LAKE COUNTY LAK-90-8.77/29.20	OHIO
	FHWA REGION 5
	FEDERAL PROJECT

CHANGE ORDER

JOINT DETAILS

BR. NO. LAK-90-1487R
I-90 E.B. OVER AUBURN ROAD

EXPANSION JOINT MODIFICATIONS - DETAIL A (RAISING ORIGINAL JOINT 0" TO 4" - REAR ABUTMENT)

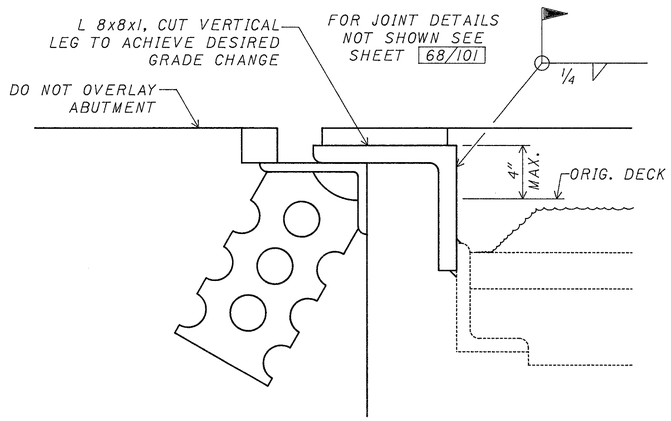
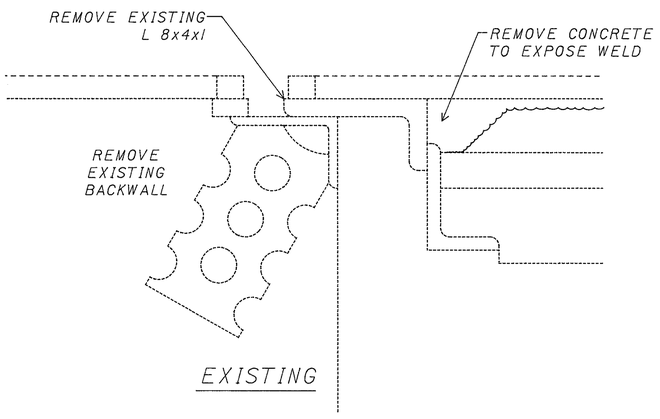
PROPOSED

EXISTING

EXPANSION JOINT MODIFICATIONS - DETAIL B RAISING JOINT 4" TO 9" - REAR ABUTMENT

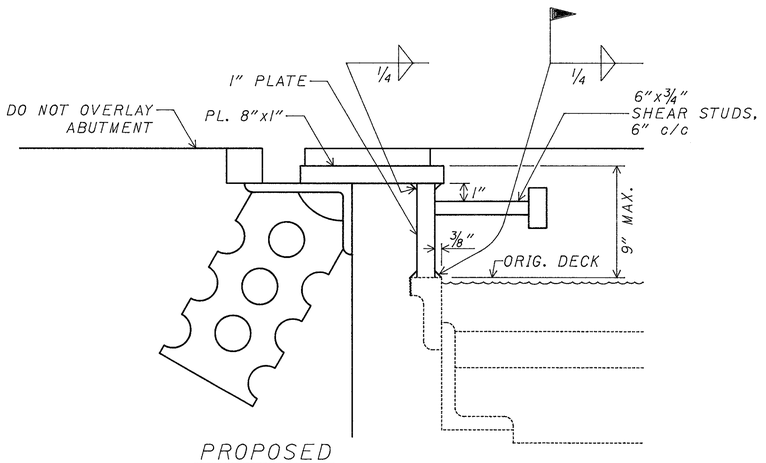
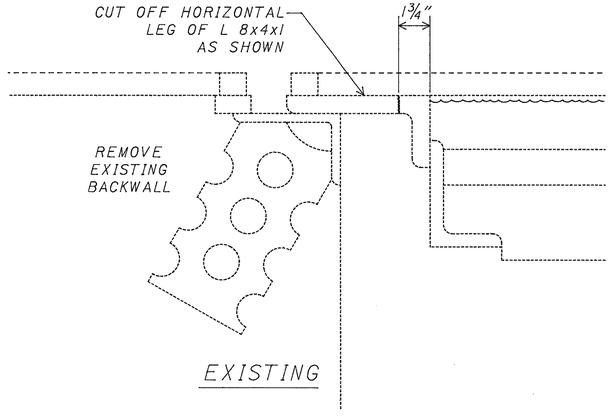
PROPOSED

EXISTING

EXPANSION JOINT MODIFICATIONS - DETAIL C (PREVIOUS OPEN BAY - REAR ABUTMENT)

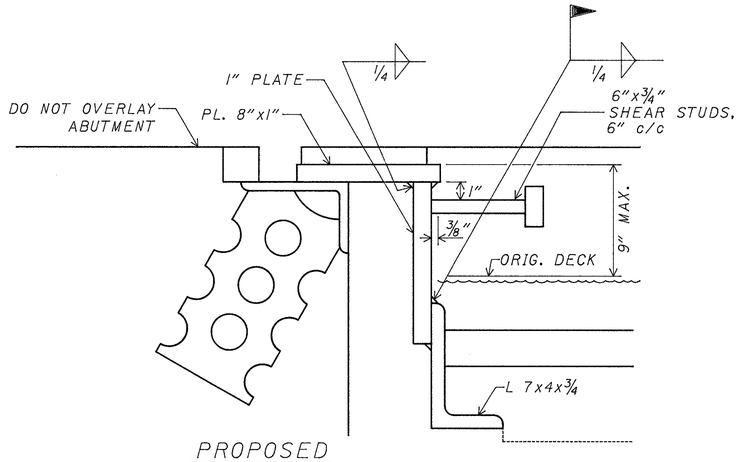
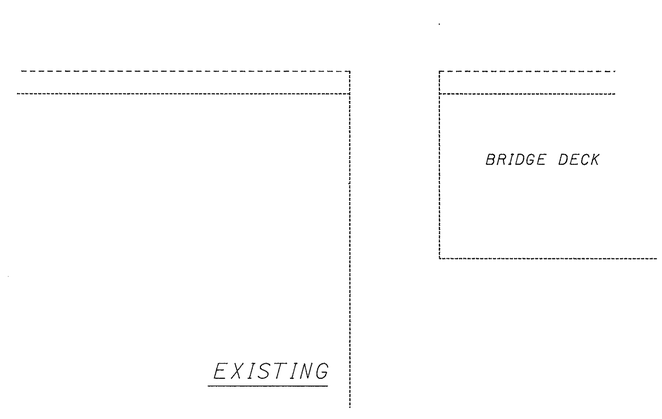
PROPOSED

EXISTING
